Chip-to-module CAUI-4 CTLE peaking tolerancing

Problem statement

Comment 67

83E.3.1 page 166 line 22

Eye opening for maximum allowed V_{pkpk}

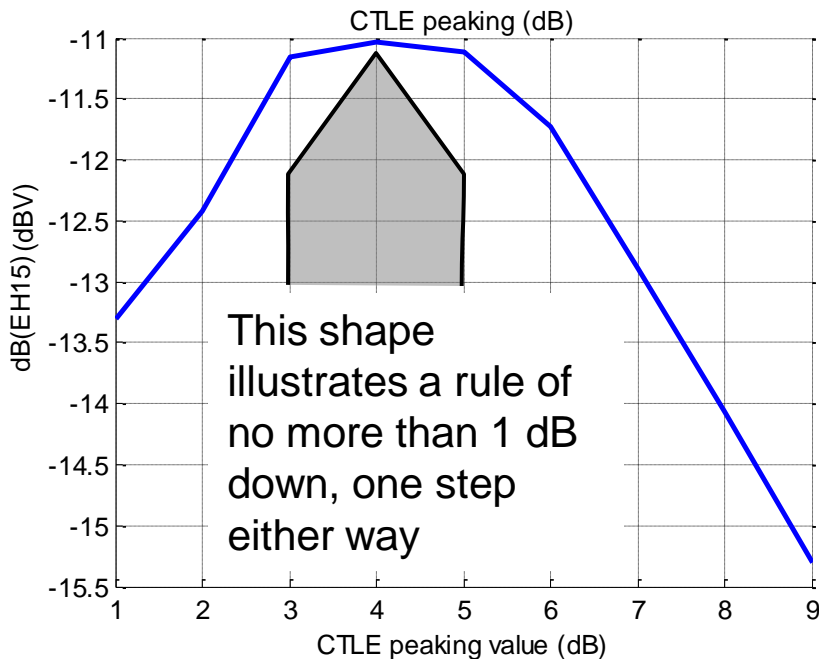
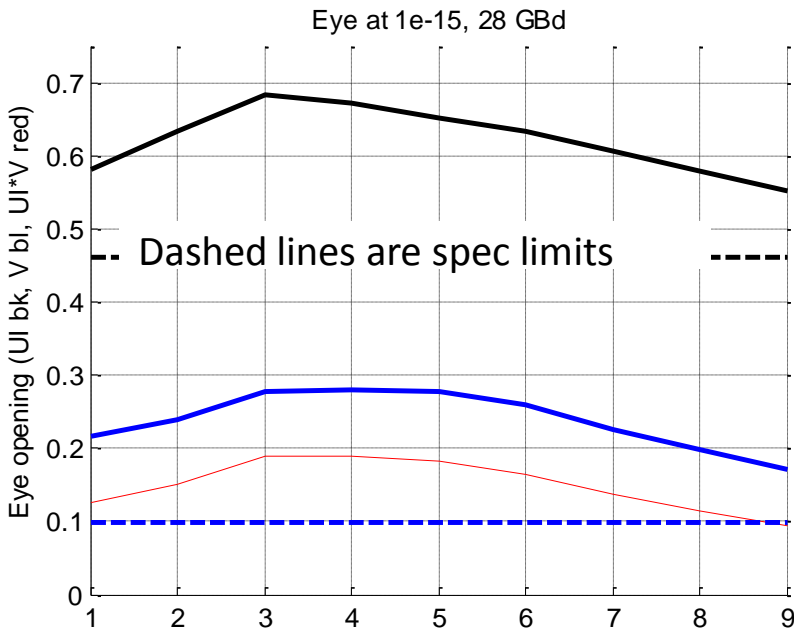
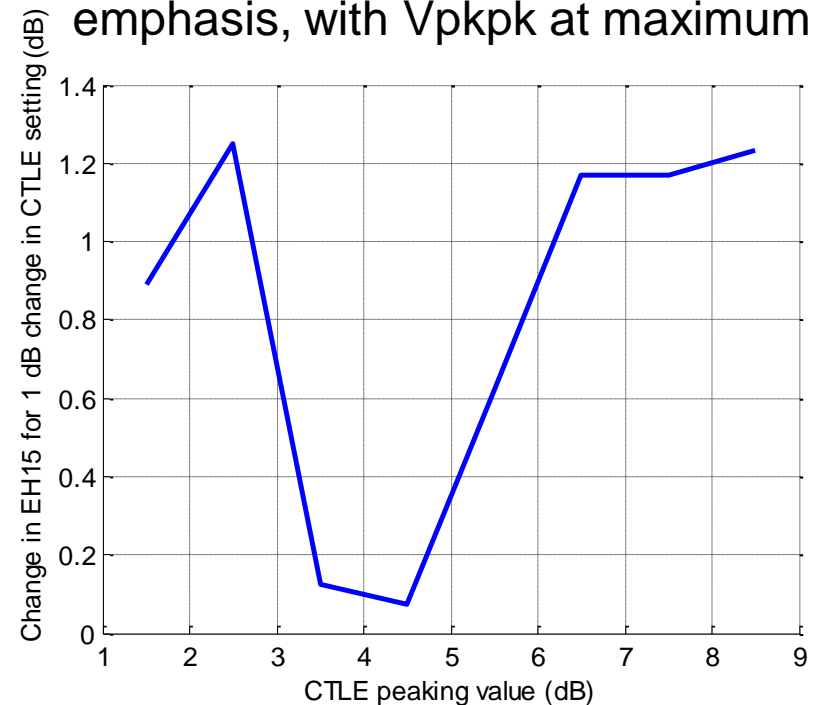
In this benign example, host could recommend any value from 1 to 9

Slower...

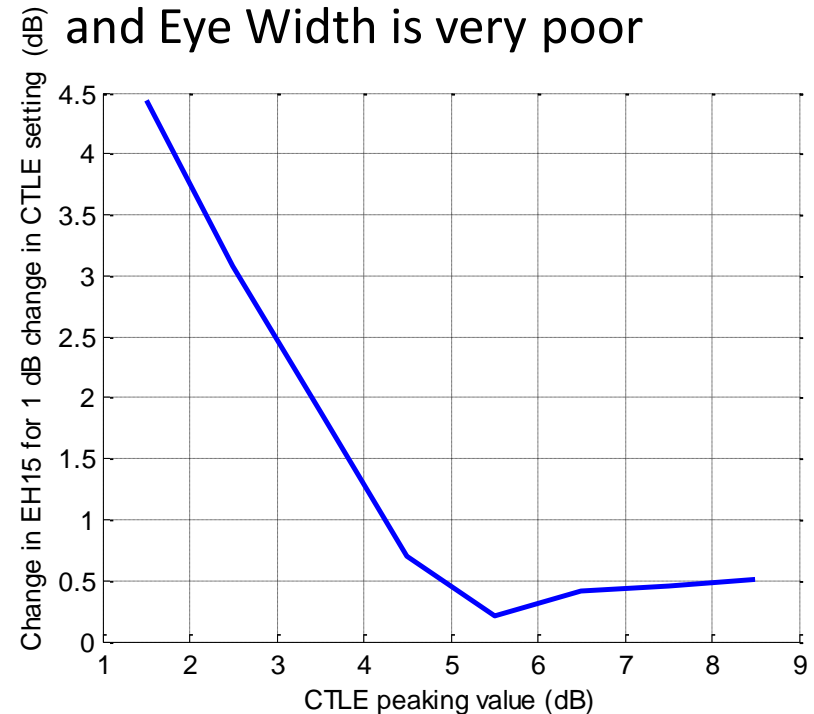
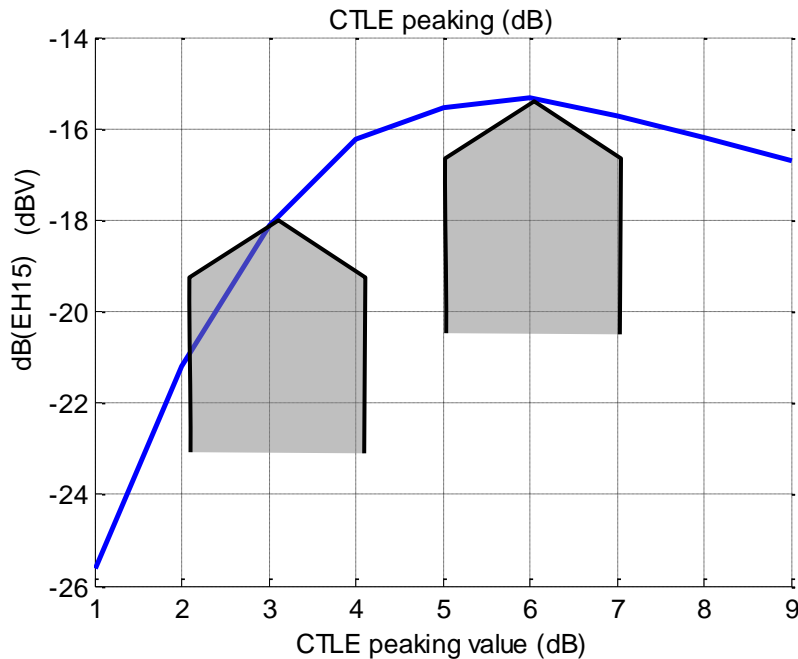
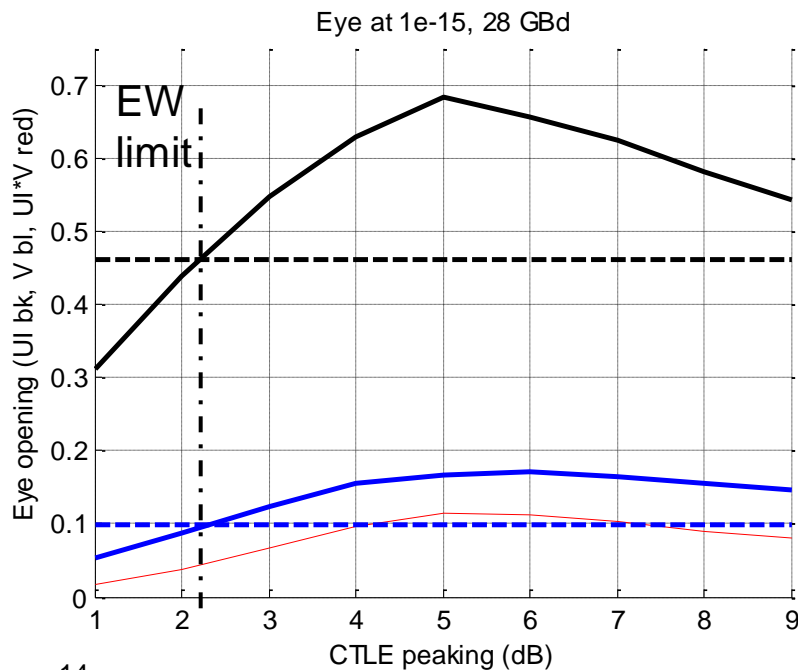
- Host could report 2 and be compliant (because eye meets spec at 3)
- Compliant module might work at 2 (3 dB less Eye Height than at 3, and failing Eye Width) but might not at 1, where the height is 8 dB less than at 3, and falling off at 4 dB/step, and Eye Width is very poor

Even slower

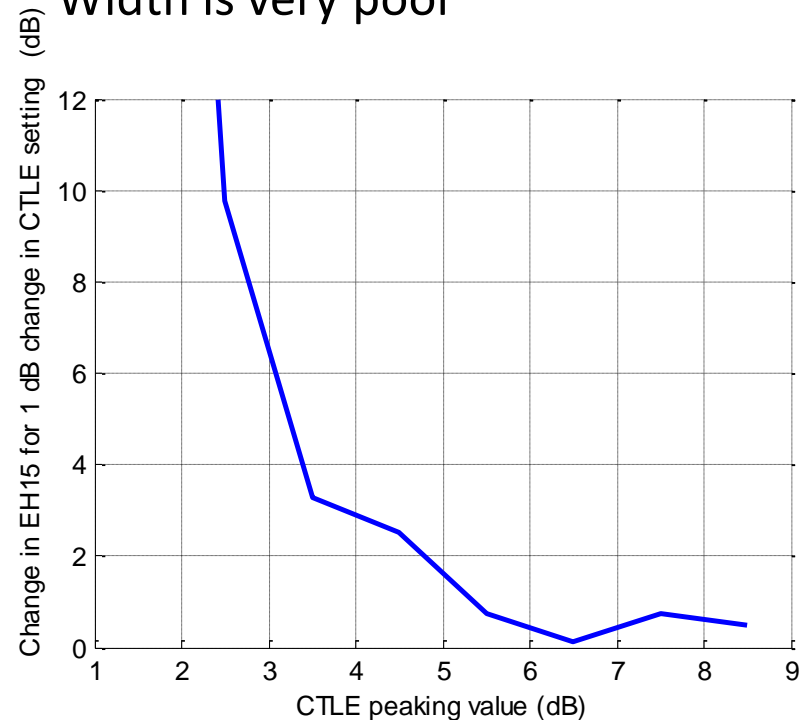
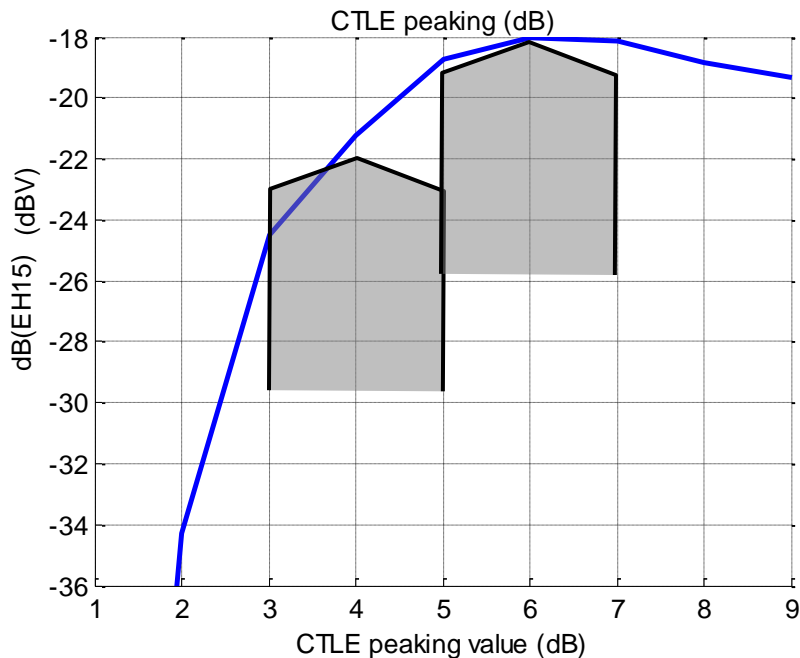
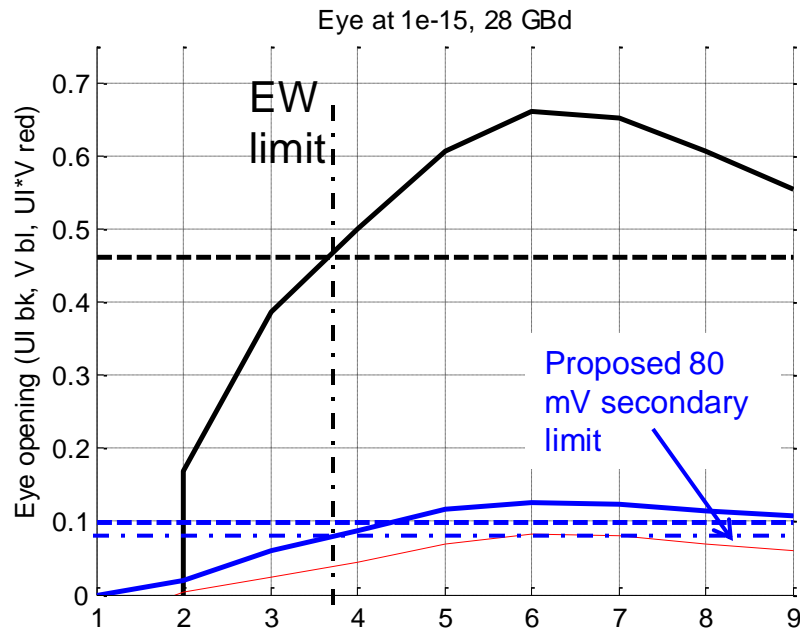
- Host could report 4 and be compliant (because eye meets spec at 5)
- Compliant module set at 3, gets 3 dB less height than at 4, and falling off at 6 dB/step, and Eye Width is very poor
